**RE: Defect Information Report – Supplemental Report No. 5
12V-074, FL-622, HDEP EPA07/EPA10 High Pressure Fuel Line, Pump to Rail
Dealer Notice – Revision 3**

18SP698 – EPA07/10 Three-Filter Fuel System DD15/16 High Pressure Fuel Feed Lines, Mounting Bracket, Vibration Dampers and P-clips Service Kit (P/N: A4720707932)

**18SP697 – EPA07/10 Three-Filter Fuel
System DD13 High Pressure Fuel Feed Lines,
Mounting Bracket, Vibration Dampers and
P-clips Service Kit
(P/N: A4710705935)**

Subject: **Safety Recall 12C2-Rev3**
EPA07/10 DD Platform High Pressure Fuel Feed Lines

Figure 1 – Top Fuel Rail Clamp Bolts

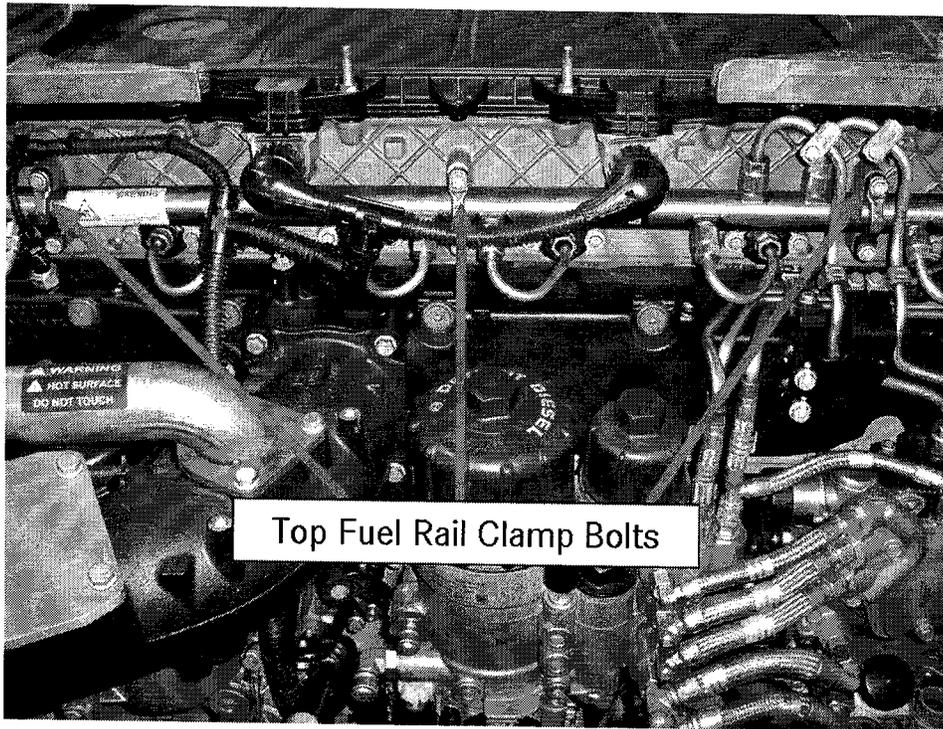
2. Inspect the fuel rail clamp bolts for any missing bolts.
 - 2A. If any are found missing, replace all fuel rail tensioning clamps and all fuel rail tensioning clamp bolts with the Fuel Rail Clamp/Bolt Kit, A4720780335 and follow 18SP693 instructions included in the kit. Installation of kit A4720780335 will require replacement of the respective Fuel Line Replacement Kit referenced in step 11. Go to step 11.
 - 2B. If no missing fuel rail bolts are found, torque only the TOP three fuel rail clamp bolts to 10N m (88 in lb) Go to step 3.

Figure 2 – DD15/16 Engines Before Engine Serial Number 472901S0012796

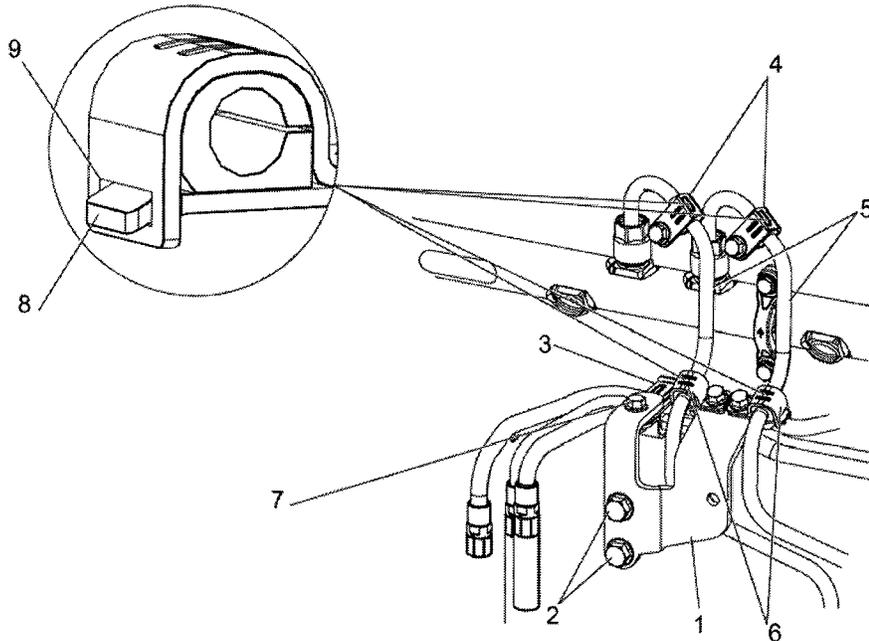
3. Perform a **VISUAL** inspection to check for missing parts or evidence of fuel leaks. Inspect the High Pressure Fuel Feed Line Mounting Bracket and its attaching bolts, the two P-Clips for the High Pressure Fuel Feed Lines, the two High Pressure Fuel Feed Line Vibration Dampers, and the two High Pressure Fuel Feed Lines. Verify the Lower P-Clip/Vibration Damper Plate is inserted into the P-Clip/Vibration Damper Window. Do not attempt to loosen, tighten or otherwise disturb any of the parts at this time. See Figures 2 and 3.

- a. If the Return Line P-clip bolt (7) is missing, replace with bolt P/N: N910105006023.
- b. If the Return Line P-clip (3) itself is missing, replace with:

- For DD13, replace with P/N: A4720780341.
 - For DD15/16 engines built before serial number 472901S0012796, replace with **P/N: A4720780041**.
 - For DD15/16 engines built after serial number 472901S0012796, replace with **P/N: A4720780341**.

- c. If any of the bolts holding the High Pressure Fuel Feed Line Vibration Dampers (4), High Pressure Fuel Feed Line P-clips (6), or High Pressure Fuel Feed Line Mounting Bracket (2) are missing or damaged, proceed to step 11.

- d. If any part of the High Pressure Fuel Feed Line Vibration Dampers (4), High Pressure Fuel Feed Line P-clips (6), or Lower P-clip/Vibration Damper Plate (8) are missing or damaged, proceed to step 11.

- e. If the Lower P-clip/Vibration Damper Plate (8) is not inserted in the P-clip Window (9), proceed to step 11.
- f. If no parts are missing or damaged, and no evidence of fuel leaks are observed, proceed to step 5.

Figure 4 – Paint Marks on Vibration Damper Bolts and High Pressure Fuel Feed Line P-Clip Bolts

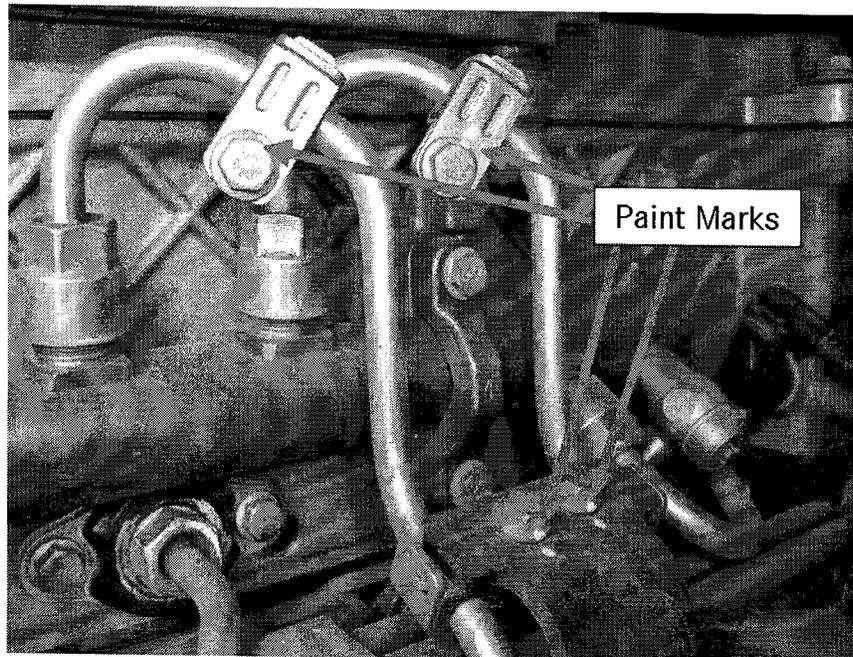
5. Begin a **PHYSICAL** inspection by doing the following: See Figure 4.
 - a. Using a paint pen, scribe a line across the two Vibration Damper bolts to the middle of the Vibration Damper.
 - b. Using a paint pen, scribe a line across the two bolts holding the two High Pressure Fuel Feed Line P-Clips to the Mounting Bracket.

6. Torque all four bolts on the two Vibration Dampers and the two High Pressure Fuel Feed Line P-Clips to 12N·m (106 in·lb).
7. Inspect the scribe lines on the two Vibration Dampers and the two High Pressure Fuel Feed Line P-Clips to make sure the scribe lines have not moved. If any of the scribe lines are no longer inline, proceed to step 11.

Figure 5 – Paint Marks on Mounting Bracket Bolts

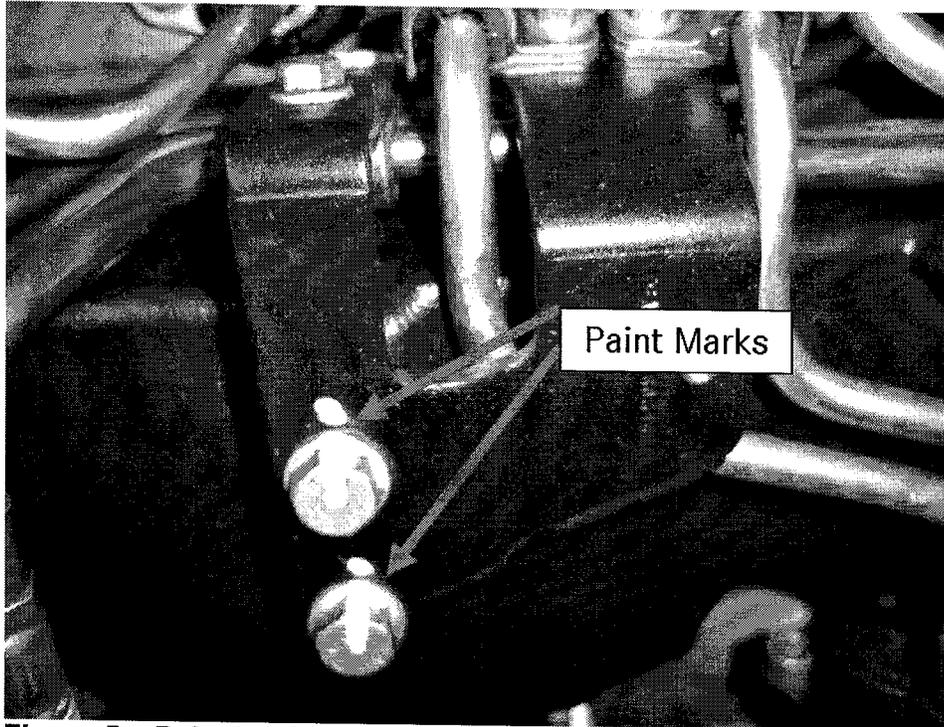
8. Using a paint pen, scribe a line from the middle of the two Mounting Bracket bolts to the Mounting Bracket. See Figure 5.

9. Torque both Mounting Bracket bolts to 25N·m (18 ft·lb).
10. Inspect the scribe lines on the two Mounting Bracket bolts and Mounting Bracket.
 - a. If any of the scribe lines are no longer inline, proceed to step 11.
 - b. If the scribe lines are still inline, proceed to step 12.

Figure 6 – 12C2 Identification on Fuel Rail.

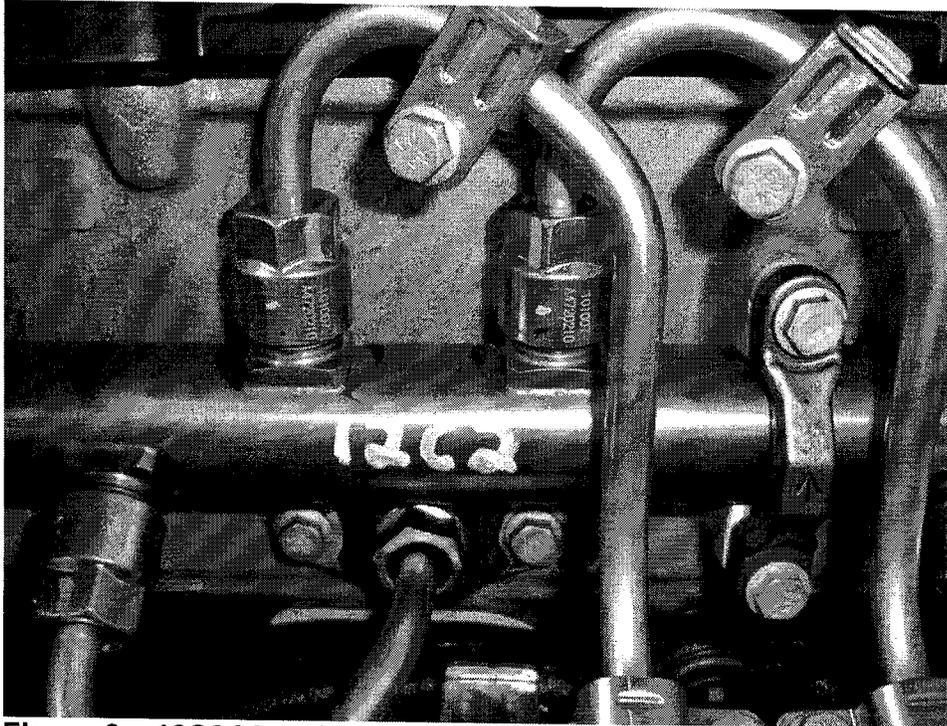
- Using a paint pen, write the campaign number "12C2" on the Fuel Rail under the High Pressure Fuel Feed Line fittings. See Figure 6.
